BROWNS FERRY NUCLEAR PLANT, UNIT 1

AMENDMENT TO FACILITY OPERATING LICENSE

Amendment No. 206  
License No. DPR-33

BROWNS FERRY NUCLEAR PLANT, UNIT 3

# Figure 3.5.M-1 BFN Power/Flow Stability Regions

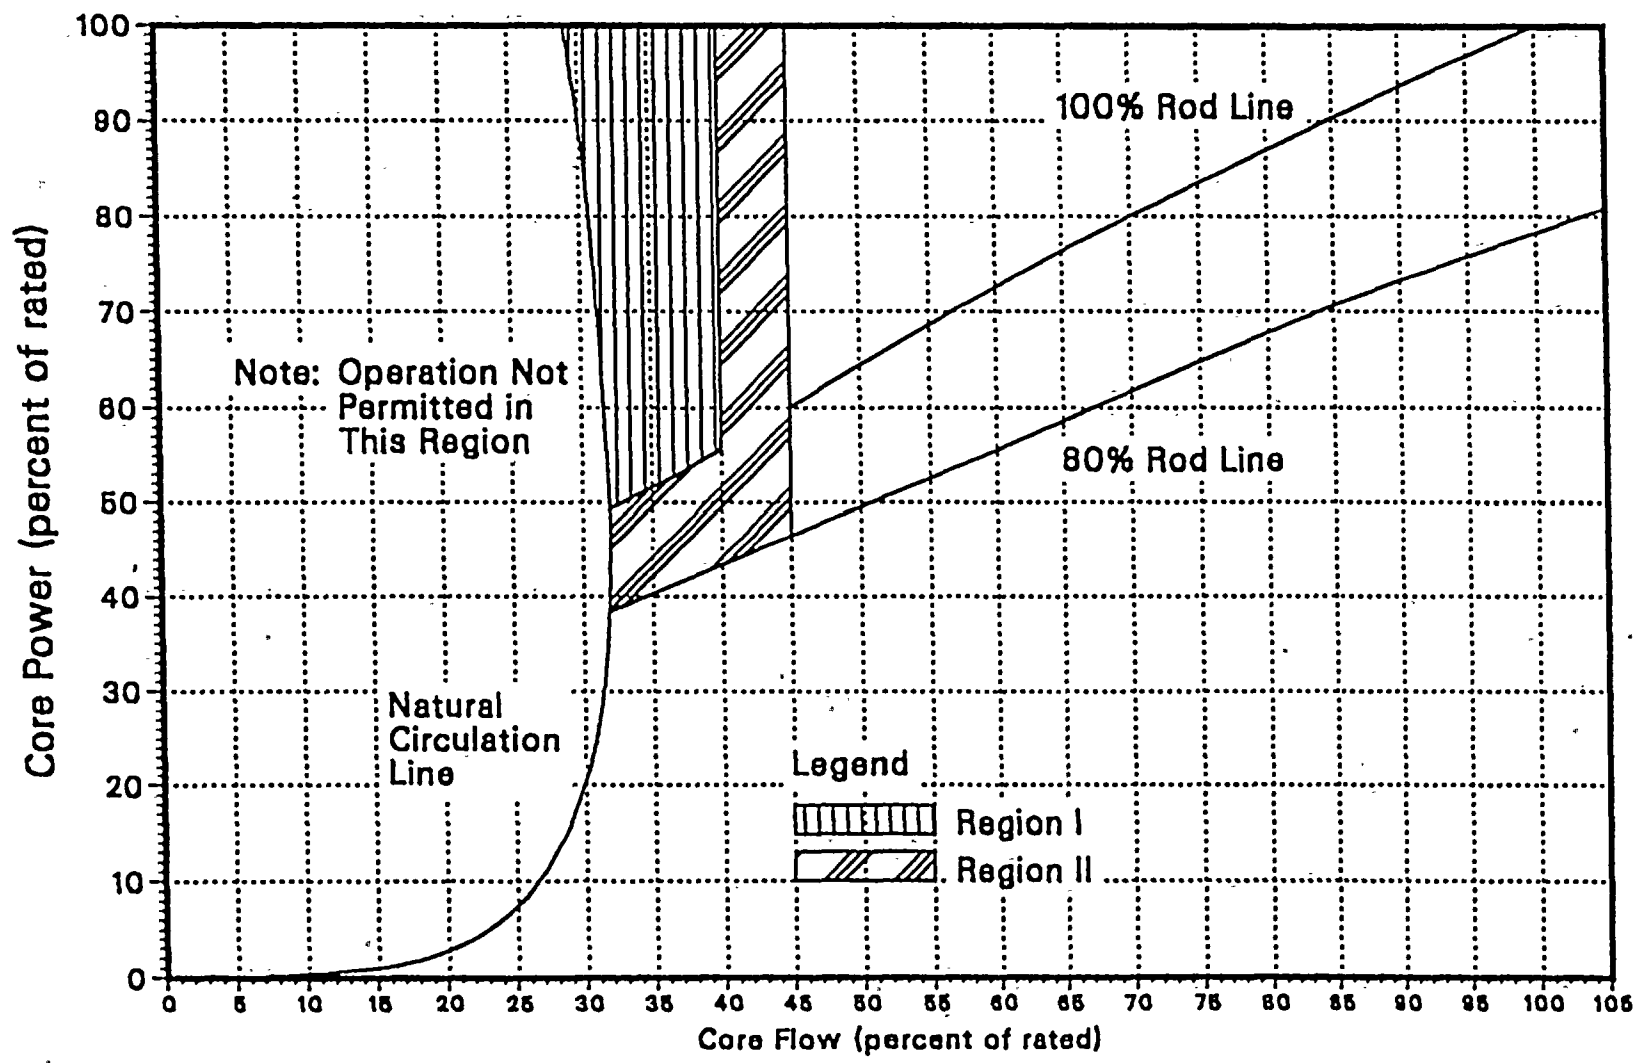
1. The reactor shall not be operated at a thermal power and core flow inside of Regions I and II of Figure 3.5.M-1.
2. If Region I of Figure 3.5.M-1 is entered, immediately initiate a manual scram.
3. If Region II of Figure 3.5.M-1 is entered:
  - a. Immediately initiate action and exit the region within 2 hours by inserting control rods or by increasing core flow (starting a recirculation pump to exit the region is not an appropriate action), and
  - b. While exiting the region, immediately initiate a manual scram if thermal-hydraulic instability is observed, as evidenced by APRM oscillations which exceed 10 percent peak-to-peak of rated or LPRM oscillations which exceed 30 percent peak-to-peak of scale. If periodic LPRM upscale or downscale alarms occur, immediately check the APRM's and individual LPRM's for evidence of thermal-hydraulic instability.

1. Verify that the reactor is outside of Region I and II of Figure 3.5.M-1:
  - a. Following any increase of more than 5% rated thermal power while initial core flow is less than 45% of rated, and
  - b. Following any decrease of more than 10% rated core flow while initial thermal power is greater than 40% of rated.

The minimum margin to the onset of thermal-hydraulic instability occurs in Region I of Figure 3.5.M-1. A manually initiated scram upon entry into this region is sufficient to preclude core oscillations which could challenge the MCPR safety limit.

Because the probability of thermal-hydraulic oscillations is lower and the margin to the MCPR safety limit is greater in Region II than in Region I of Figure 3.5.M-1, an immediate scram upon entry into the region is not necessary. However, in order to minimize the probability of core instability following entry into Region II, the operator will take immediate action to exit the region. Although formal surveillances are not performed while exiting Region II (delaying exit for surveillances is undesirable), an immediate manual scram will be initiated if evidence of thermal-hydraulic instability is observed.

Figure 3.5.M-1  
BFN Power/Flow Stability Regions

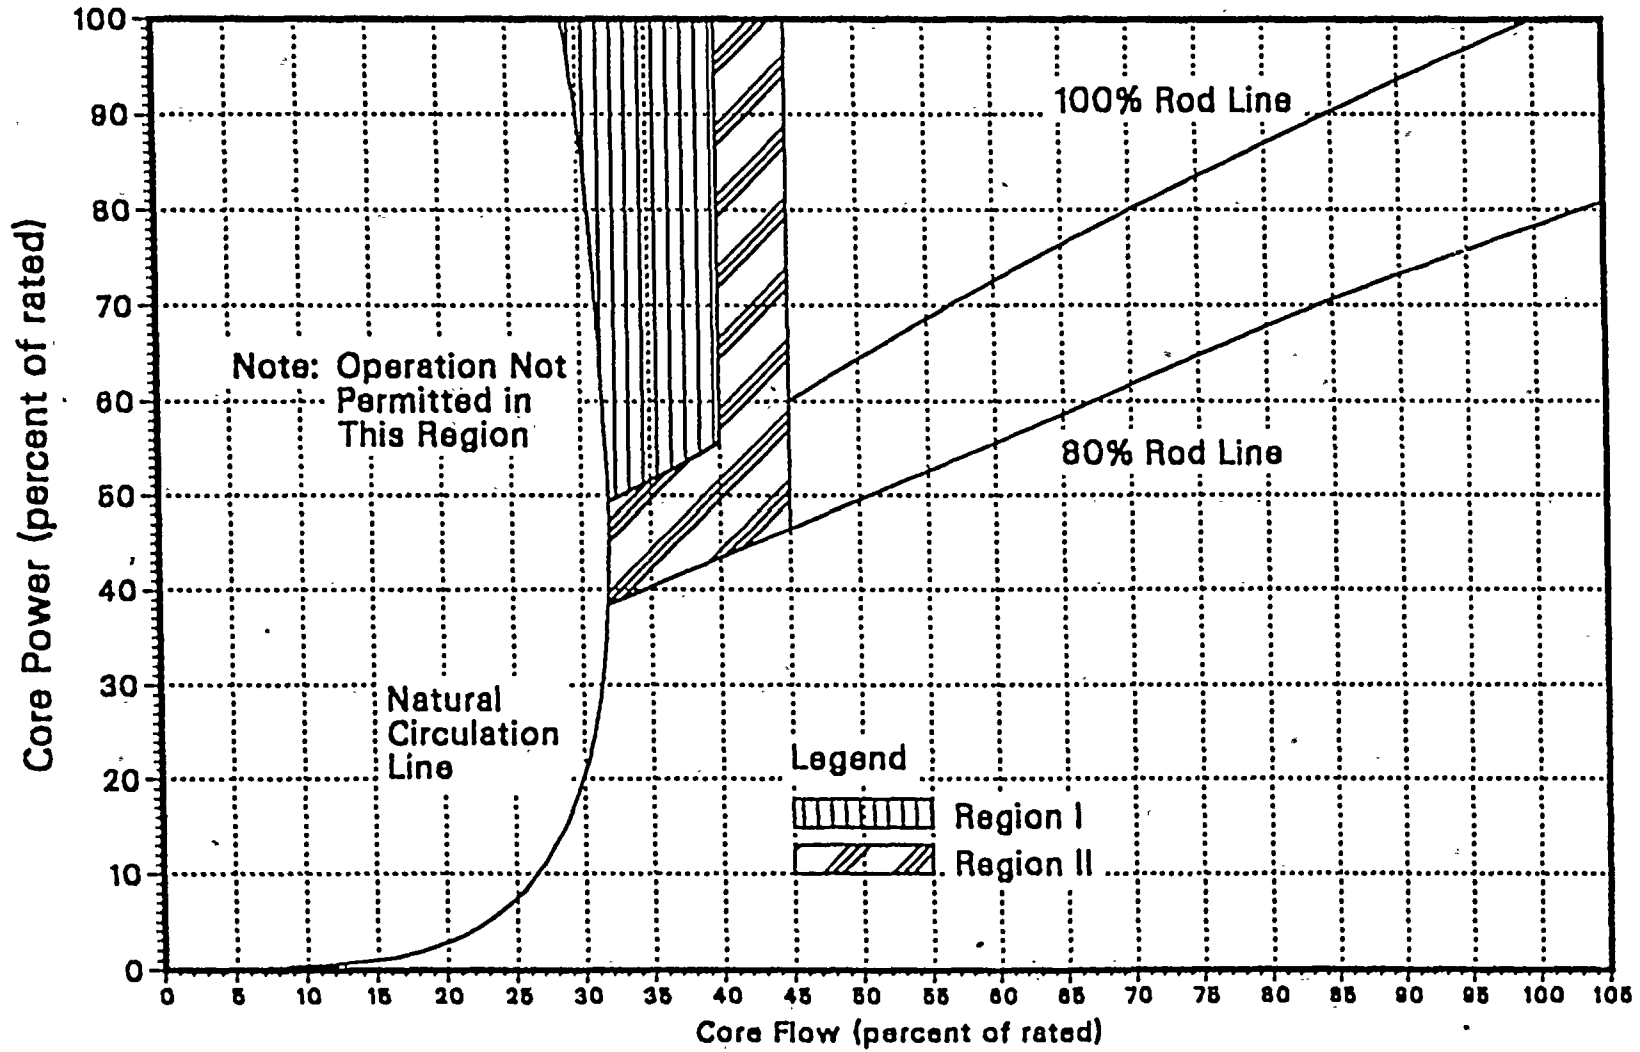
1. The reactor shall not be operated at a thermal power and core flow inside of Regions I and II of Figure 3.5.M-1.
2. If Region I of Figure 3.5.M-1 is entered, immediately initiate a manual scram.
3. If Region II of Figure 3.5.M-1 is entered:
  - a. Immediately initiate action and exit the region within 2 hours by inserting control rods or by increasing core flow (starting a recirculation pump to exit the region is not an appropriate action), and
  - b. While exiting the region, immediately initiate a manual scram if thermal-hydraulic instability is observed, as evidenced by APRM oscillations which exceed 10 percent peak-to-peak of rated or LPRM oscillations which exceed 30 percent peak-to-peak of scale. If periodic LPRM upscale or downscale alarms occur, immediately check the APRM's and individual LPRM's for evidence of thermal-hydraulic instability.

1. Verify that the reactor is outside of Region I and II of Figure 3.5.M-1:
  - a. Following any increase of more than 5% rated thermal power while initial core flow is less than 45% of rated, and
  - b. Following any decrease of more than 10% rated core flow while initial thermal power is greater than 40% of rated.

The minimum margin to the onset of thermal-hydraulic instability occurs in Region I of Figure 3.5.M-1. A manually initiated scram upon entry into this region is sufficient to preclude core oscillations which could challenge the MCPR safety limit.

Because the probability of thermal-hydraulic oscillations is lower and the margin to the MCPR safety limit is greater in Region II than in Region I of Figure 3.5.M-1, an immediate scram upon entry into the region is not necessary. However, in order to minimize the probability of core instability following entry into Region II, the operator will take immediate action to exit the region. Although formal surveillances are not performed while exiting Region II (delaying exit for surveillances is undesirable), an immediate manual scram will be initiated if evidence of thermal-hydraulic instability is observed.
